RE: Application for Certification Supplement C
Vernon Power Project (06-AFC-4)

**Vernon Power Plant (VPP)
(06-AFC-4)**

**Supplement C:
Revised General Arrangement**

FIGURE C-1

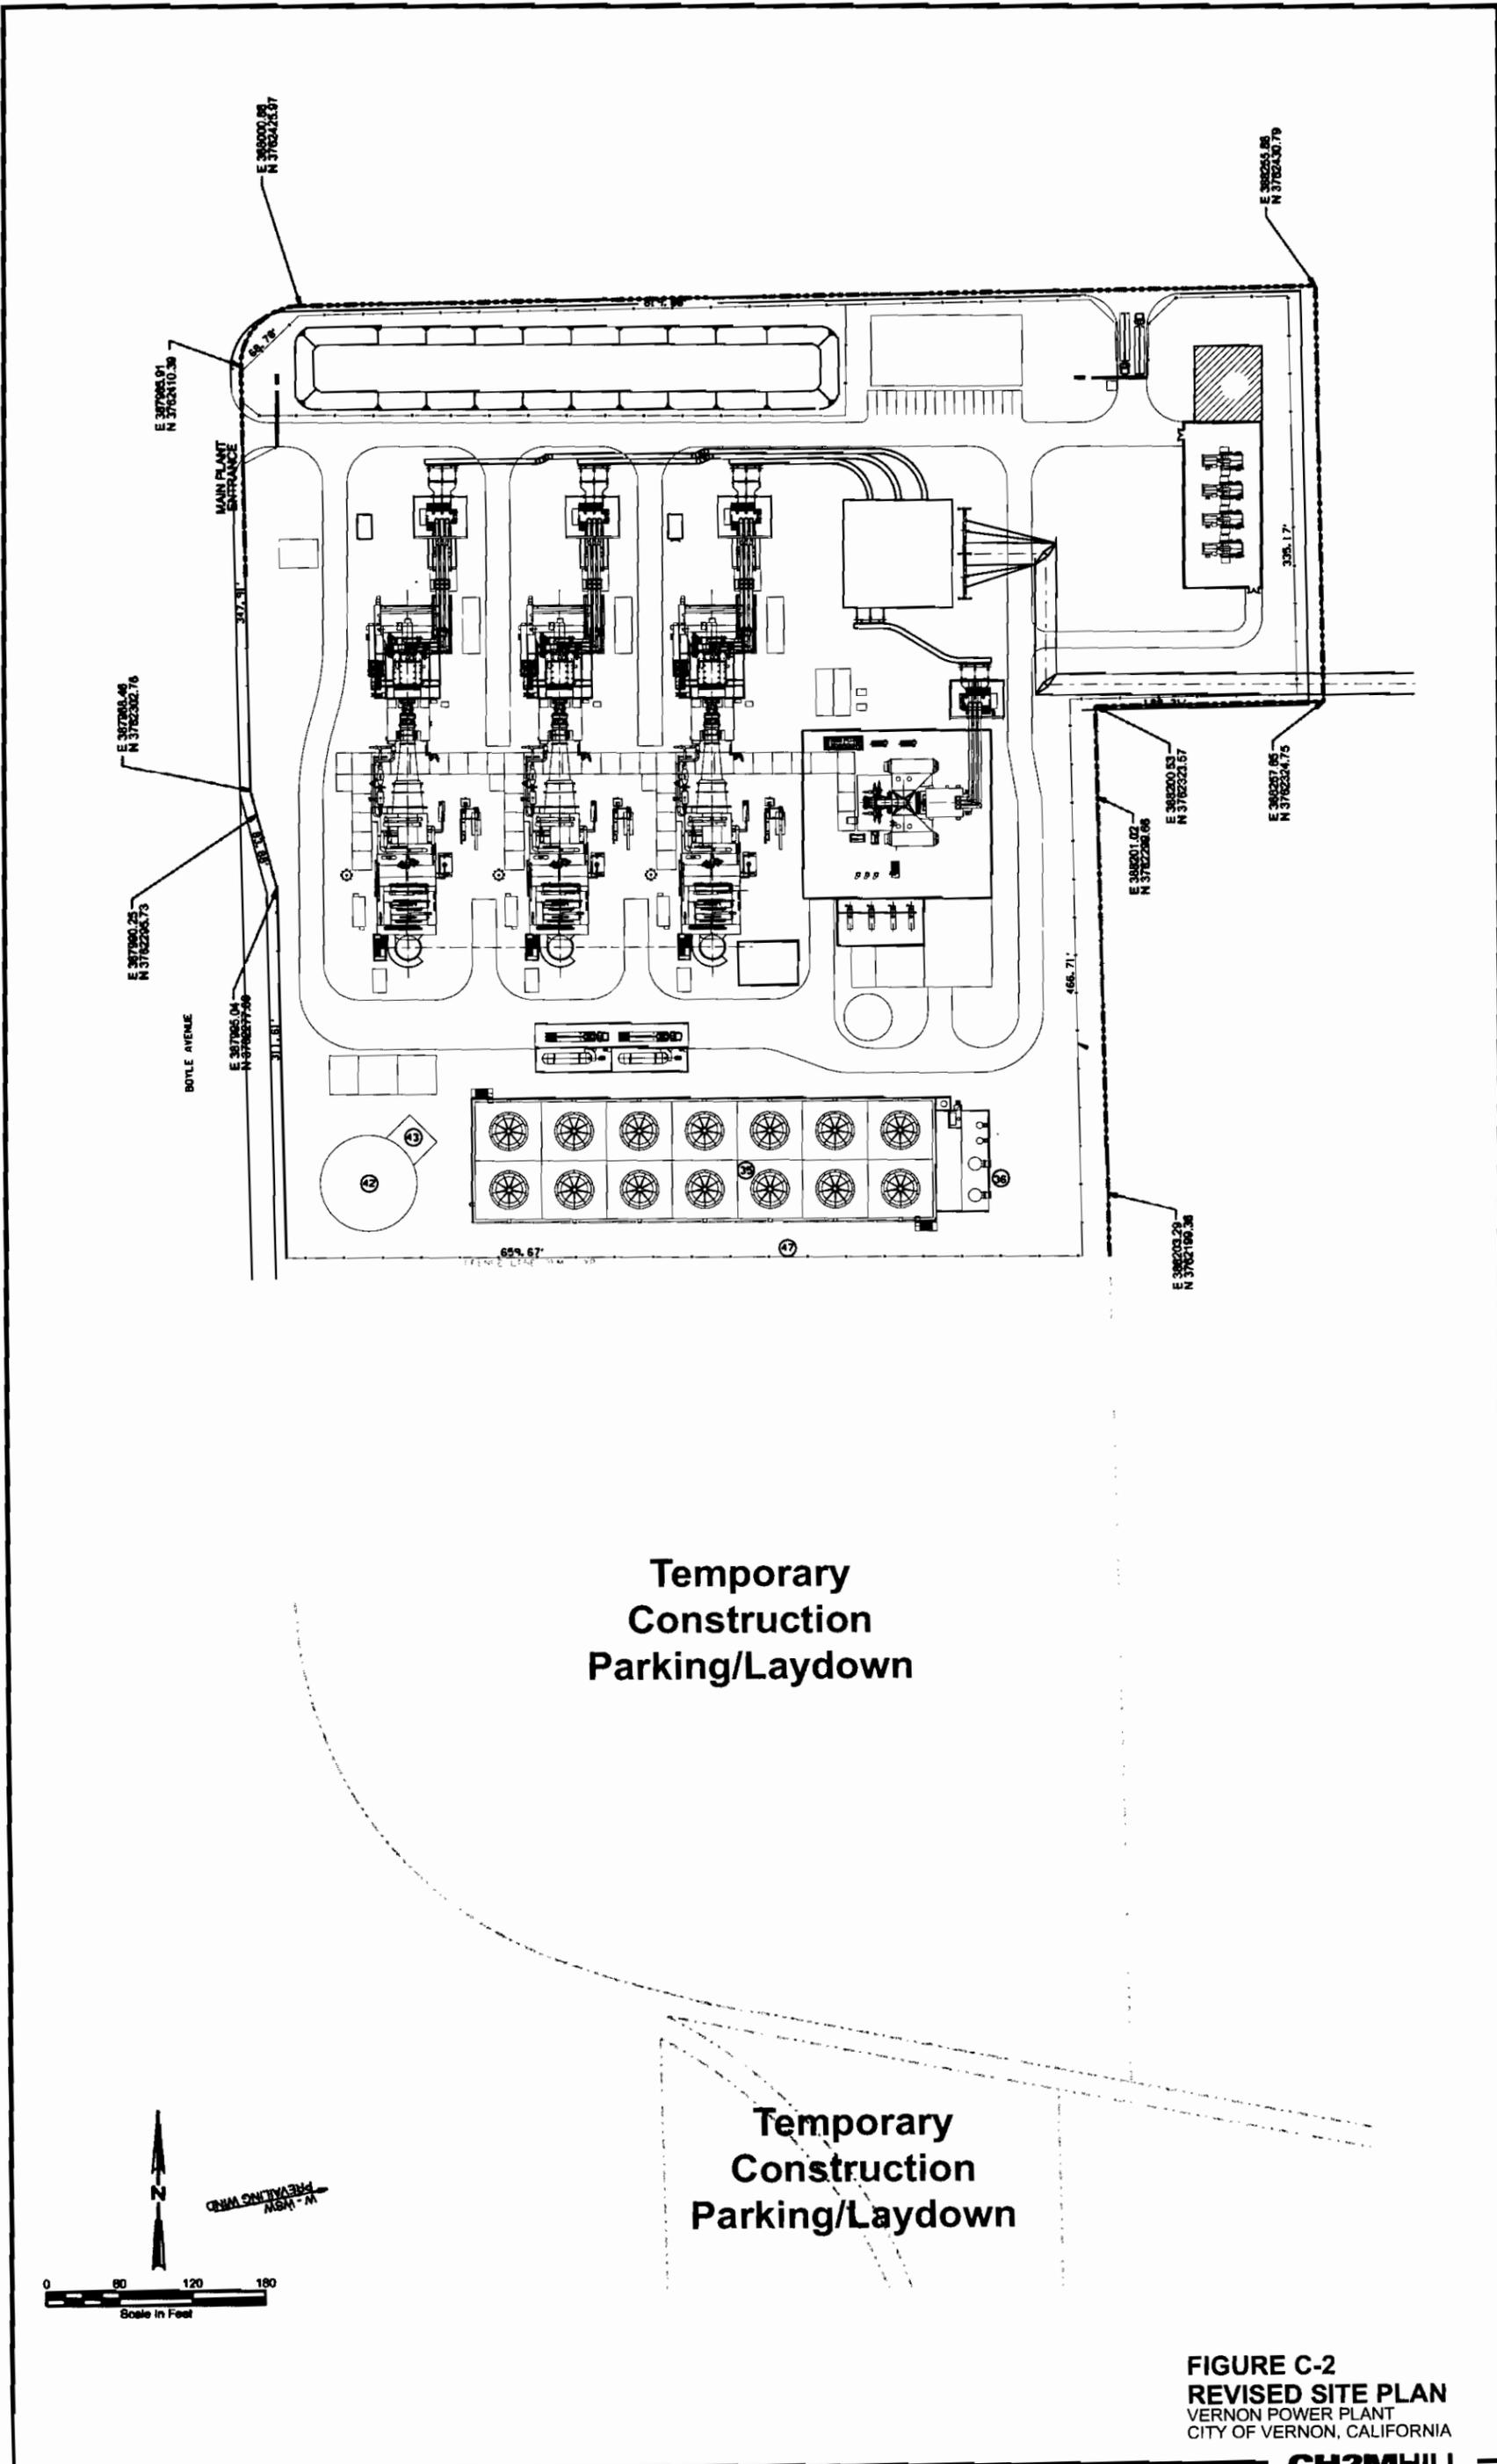
As shown on the attached Figures C-1, C-2, and C-3 (figures at the end of the document), the Applicant is proposing to move the cooling tower to the south end of the plant and rotate the power block 180 degrees. In addition, the recycled water storage tank will be moved to the south end of the project site. The detention basin and switchyard will be moved to the north end of the plant. This new general arrangement has also resulted in the relocation of other pieces of plant equipment such as the ammonia tanks, gas compressors and gas metering station, water treatment equipment, and administration building.

As shown in Figure C-1, the switchyard will be relocated to the northern portion of the site. The relocation of the switchyard would not affect the two alternative transmission line routes that are being considered. It would also not affect any offsite electric and magnetic fields.
